MVP Variance Request Form Variance Request								
	No.:				A-13			
Mou	Date Approval Requested by Contractor:				-	6/8/2018		
,		Da	ate Sub	•		spector to LEI:		
Date Received by FERC: FERC Approval Reference No.:								
			1 2110	, ippio	vai reorore	71100 140	Variance	
Requested By:	L	Brett Ladd			Spread:	Α	Type:	WS
						Variar	nce Sequence	0.40
Request Prepared By *: * The FEBC compliance me		Megan Neylon Number:						013

* The FERC compliance monitor should be alerted and given a copy of the draft variance for review prior to submittal. Location (Use either Station or Milepost)								
Station:	1180+00	To:	1190+00		lilepost:	22.20	To:	22.30
Station.	1100+00	10.	1190+00	v	iliepost.[22.20	10.	22.50
Alignment	Sheet Number:	23-24			•	ract No.:		V-HA-080

Mountain Valley Pipeline Project Variance A-13 July 5, 2018

Alignment Sheets
Attachment 1

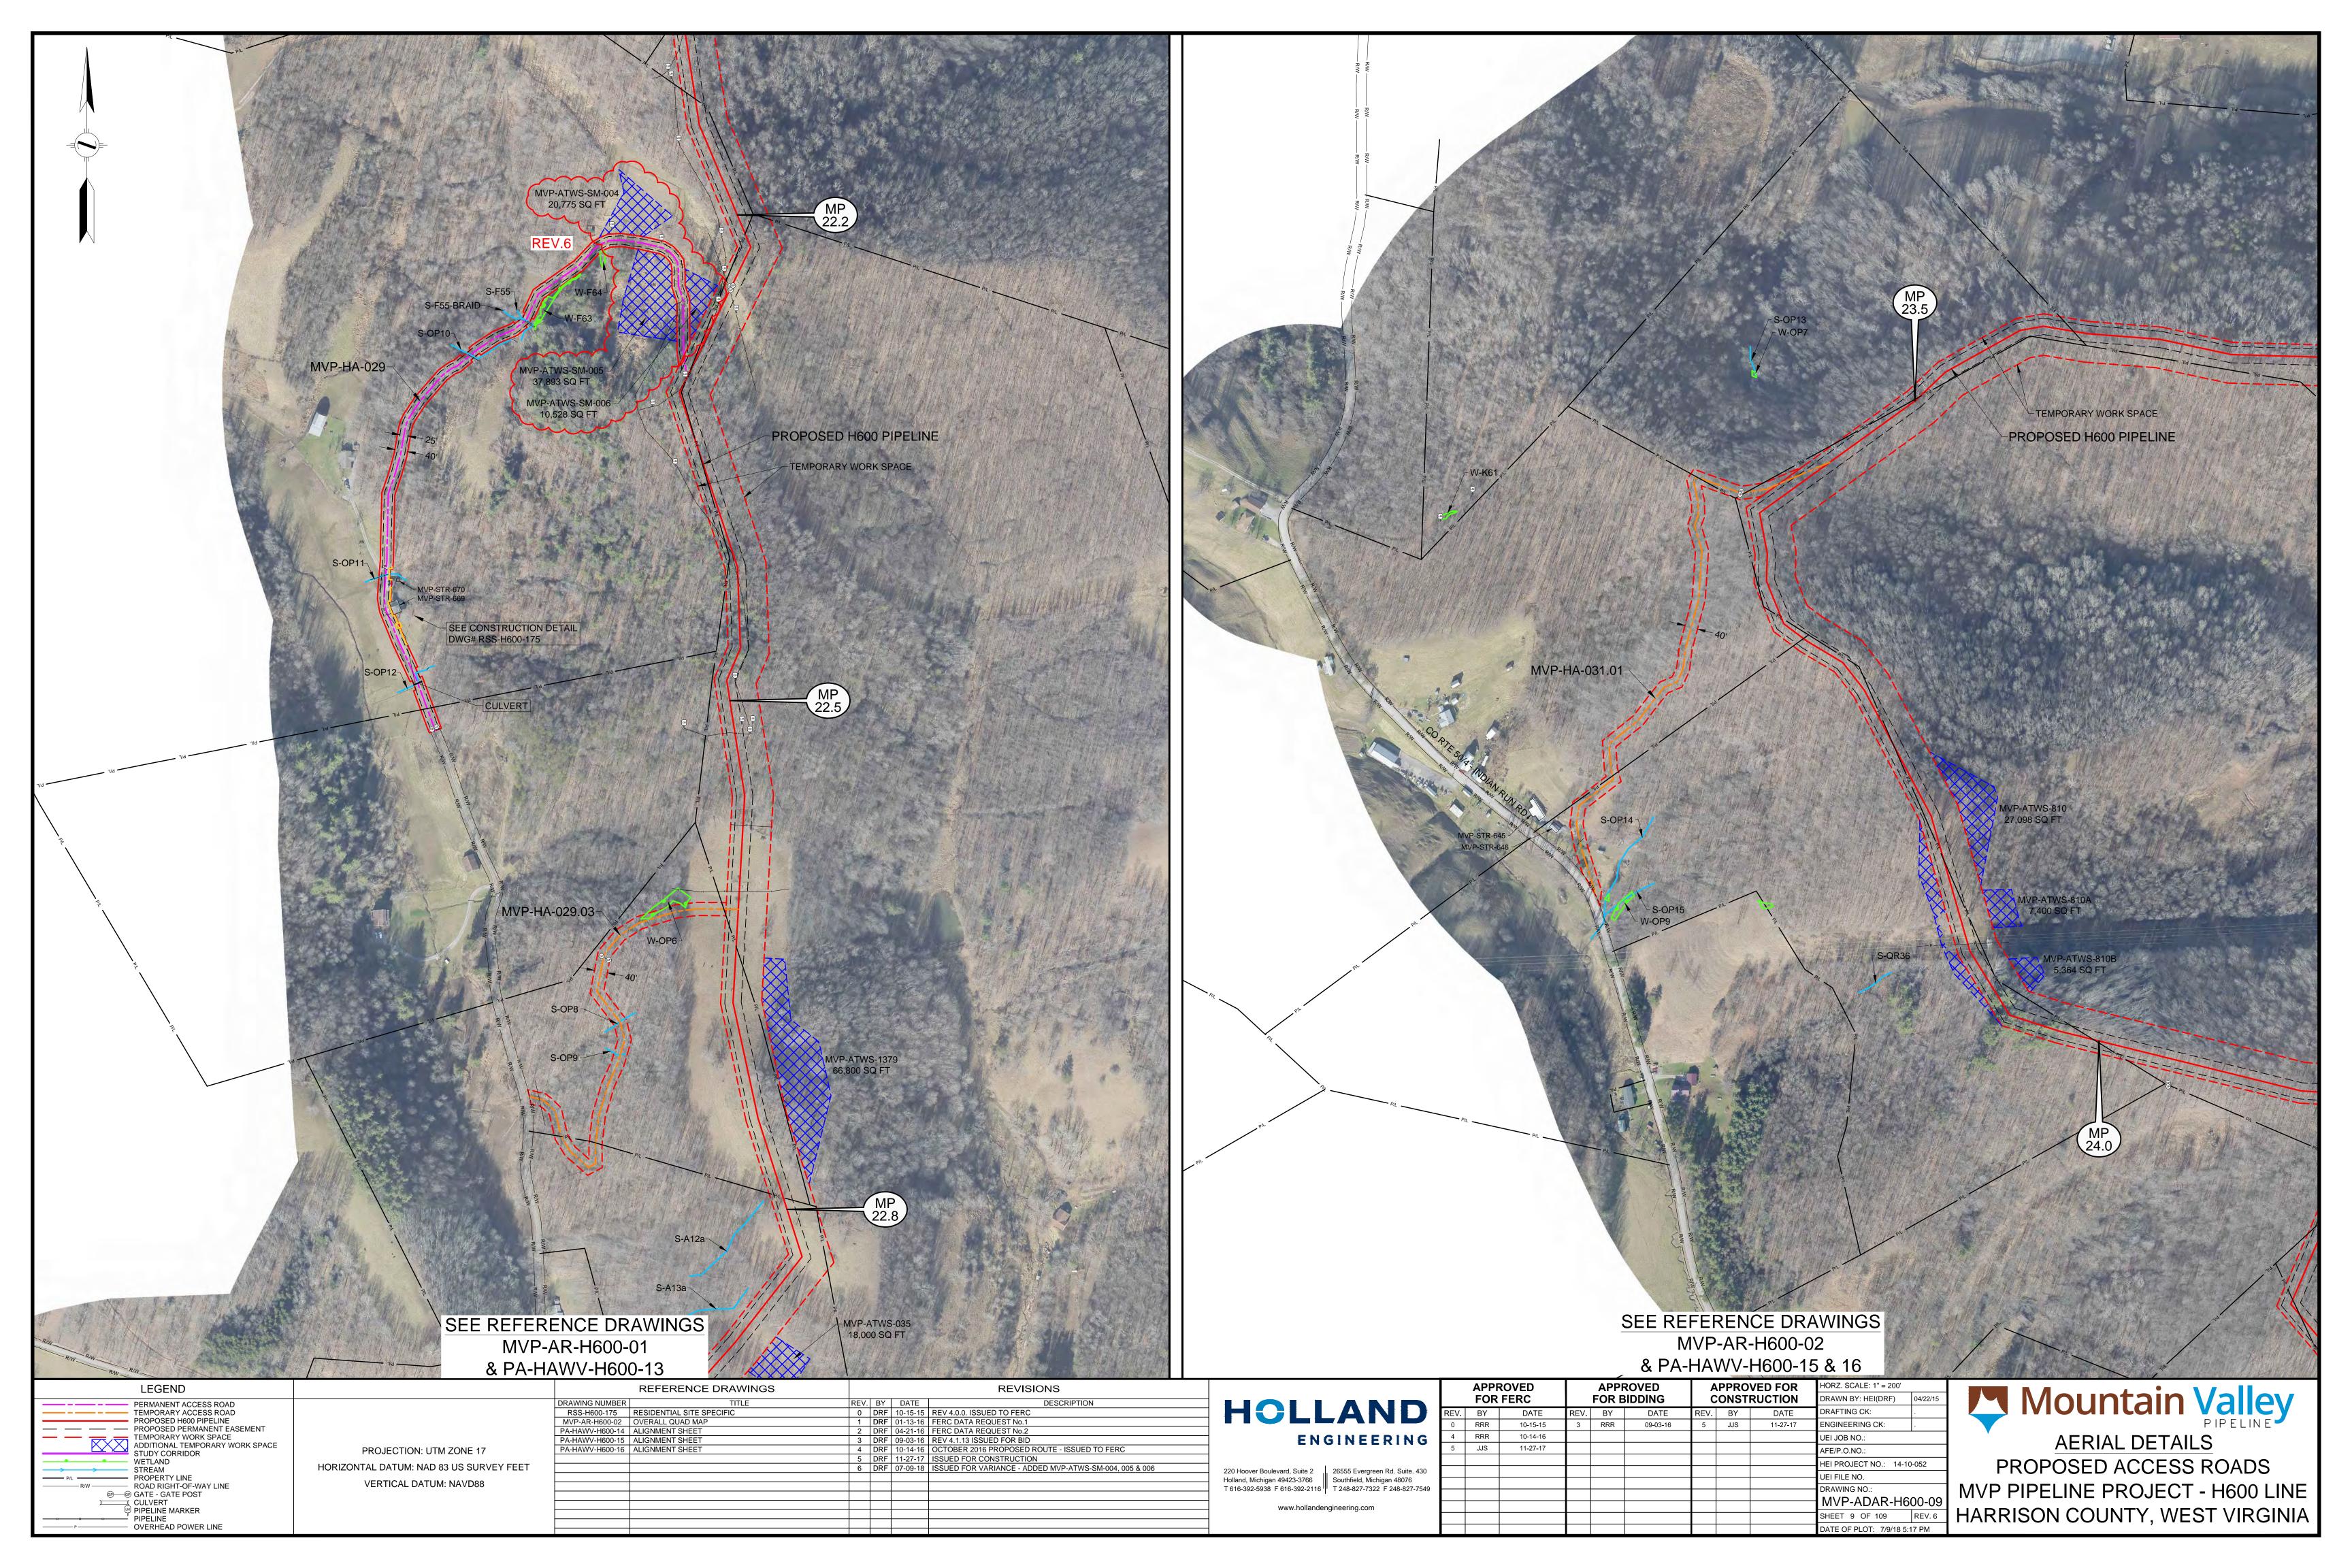
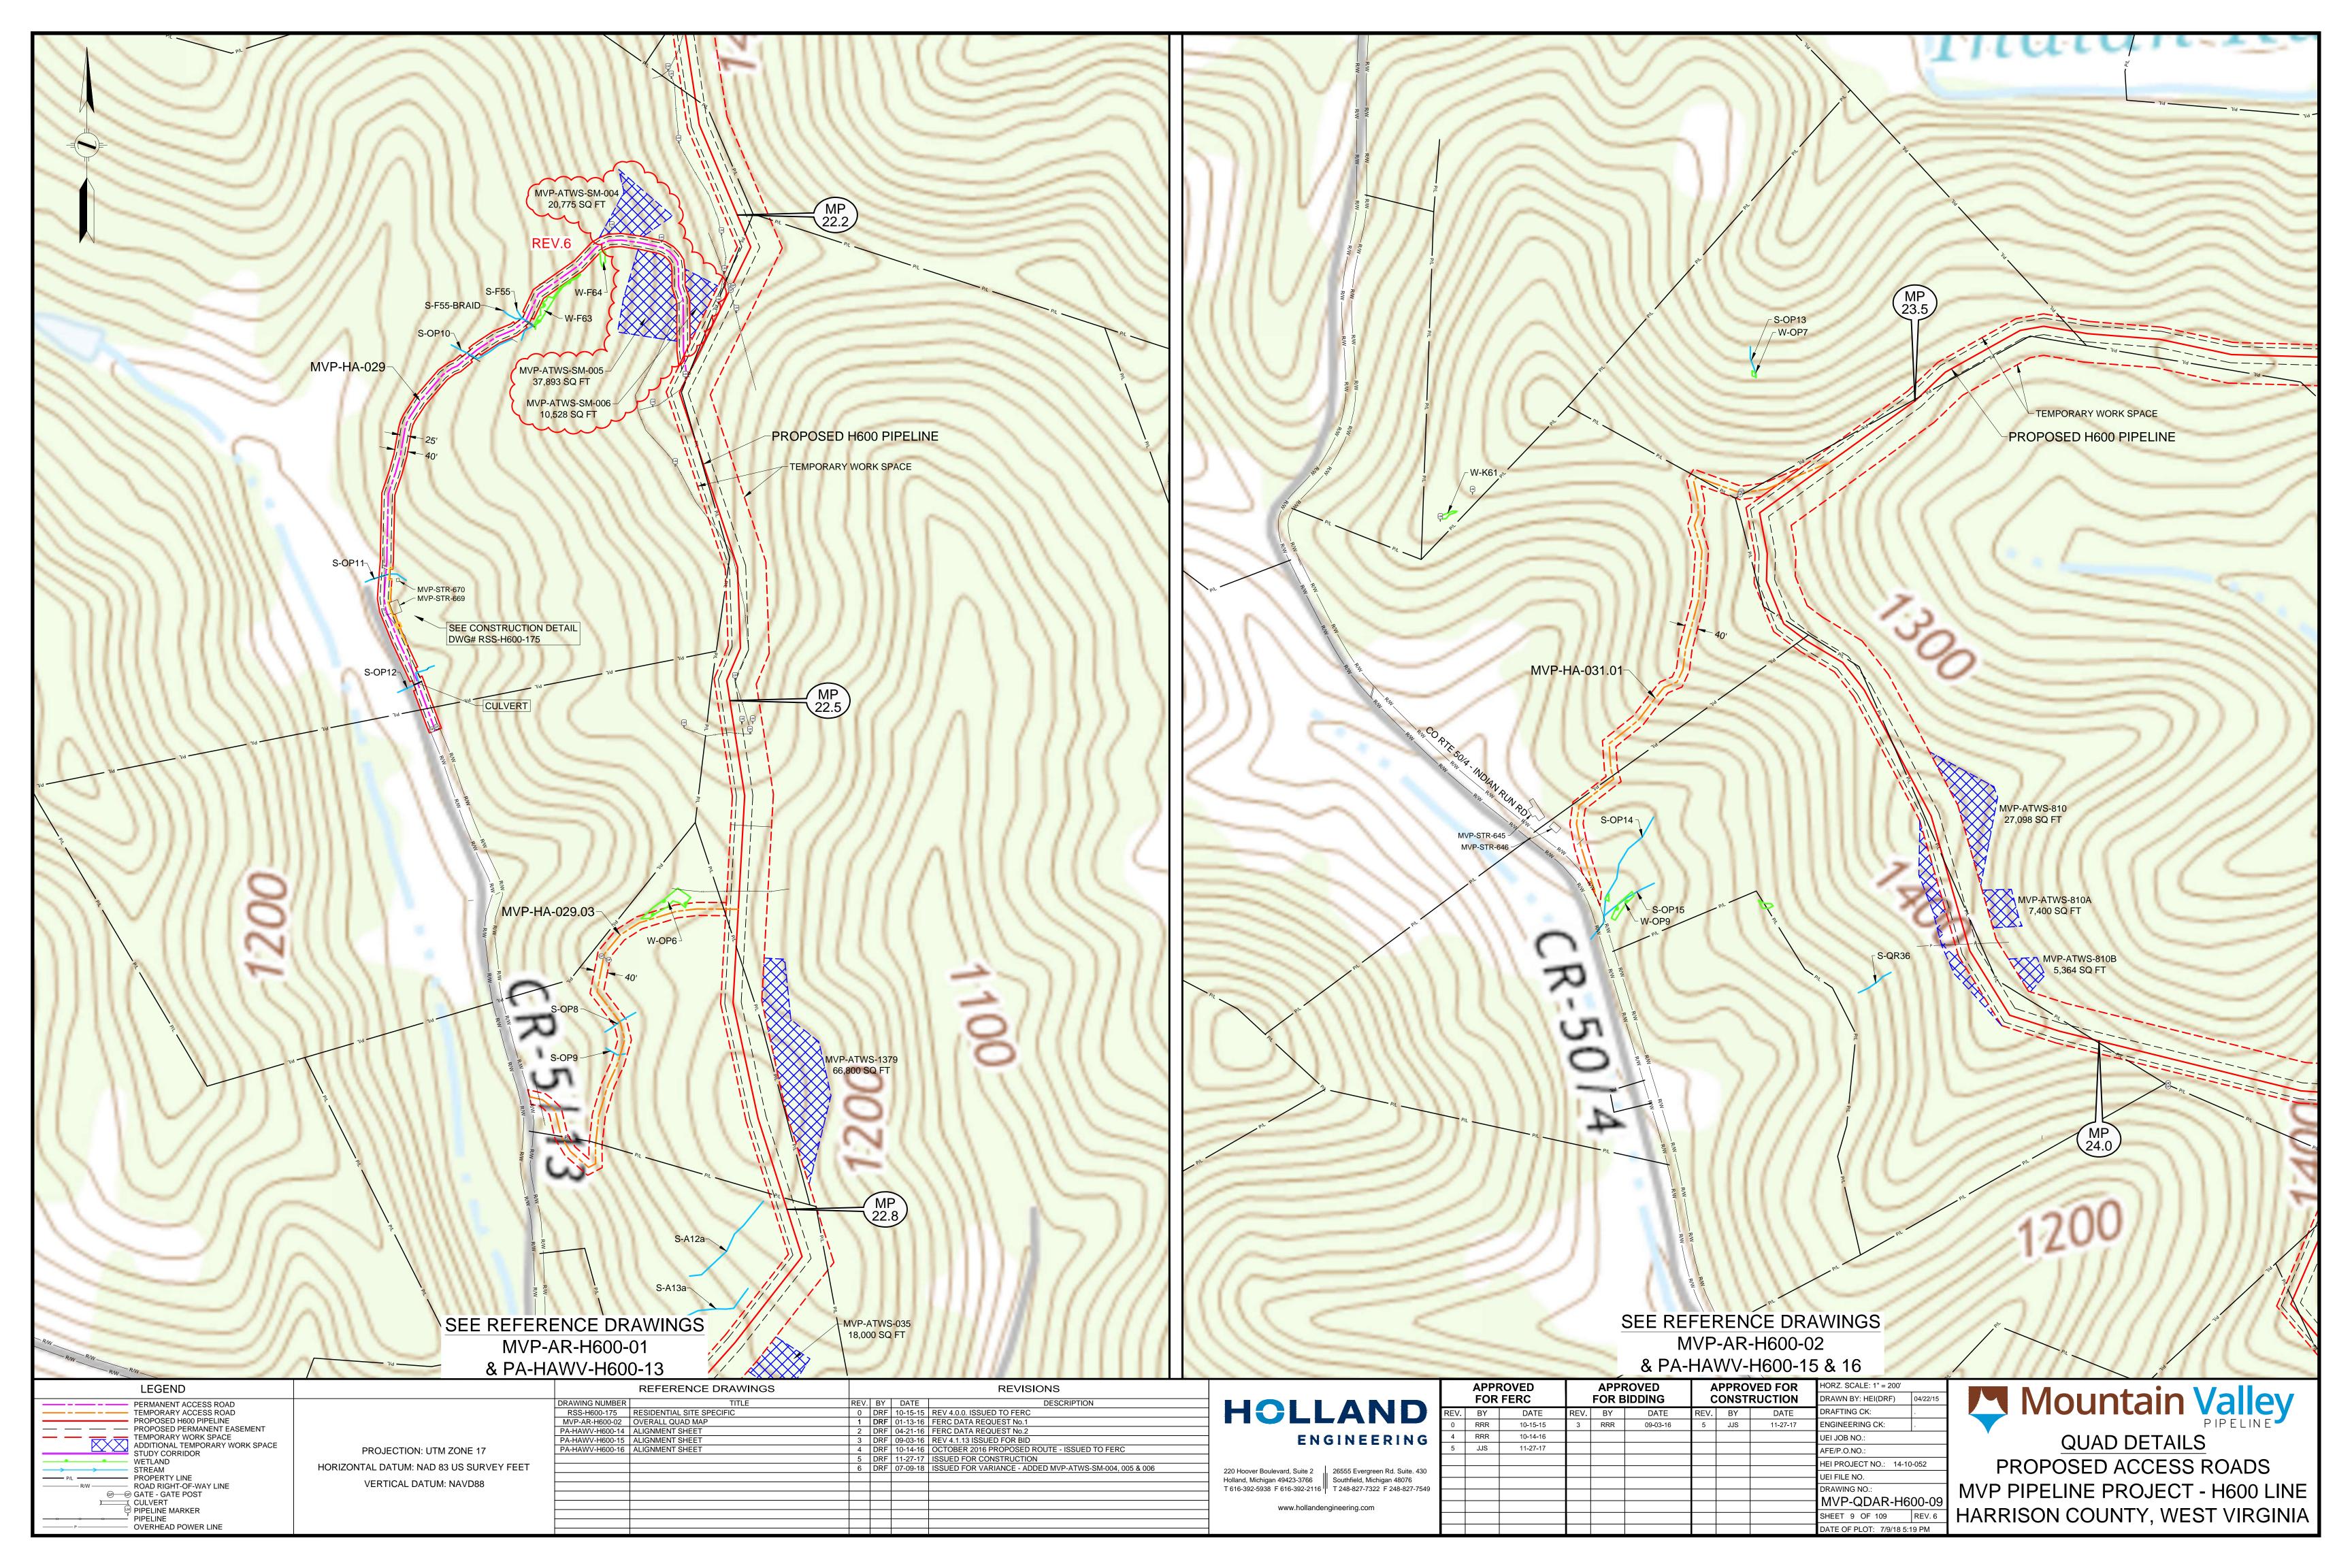
Comment Land Has/Va	matativa Cavan		Other Agenc pasture Jurisdiction				N1/A	
Current Land Use/ Ve Nearby Features (Water b	_		<i>pasture</i> L Noxious W	eed	Juris	saiction.		N/A
Area, Residence (distance	•	•	•		In or	w/in 50'	of a wetland:	Yes No
☐ Noxious Weed Area ☐ R	Raptor Nest	Residence (Dis	stance)		In or w/i	n 50' of a	a waterbody:	Yes Vo
☐ T/E Species Habitat ☐ 0	Cultural Resource Site	□w	ater Well					N/A
Other (Specify):		N/A			Wetland or V		Vaterbody ID:	N/A
Additional Stream		IVA						14/71
footage impacted:	0.00				Additio	onal Wet	land impacts:	0.00
Net acreage affected:	+ 1.59							
Tree Clearing Required:	No		Acreage of	of tree aring:		00		
		Lovel 2		arnig.	0.	00		
Variance Level:	Level 1	Level 2	✓ Level 3		_			
	Permit Plan	Procedur	res EPPN		Specificati	on D	rawing	igation Measure
	Line List				Other: Des	scribe:		
Detailed Description of Va	ariance:	Attachments?				Yes Vo		
This variance adds MVP-ATW The requested ATWSs are ne

existing and will require repair threatened or endangered sp								
requests a 1.59 acre increase							aring site deline	ations. This variance
List Attachments:	Attachment 1 - A	lianment Ch	oot: Attachment	2 - Par	ra Throata	ned and		
LIST ALLACHINENTS:	Endangered S	pecies Repo	ort; Attachment	3 - Stre	am and W	etland		
			ment 4 - Cultura DO NOT RE					
	Landowner Exhib	•						
	Variance Request Map							
Variance best C								
Variance Justification: Resources have been avoided to the extent practicable. Per approved Project plans, BMPs will be installed to minimize impacts to any								
Environmentally Sensitive Areas within/abutting the area.
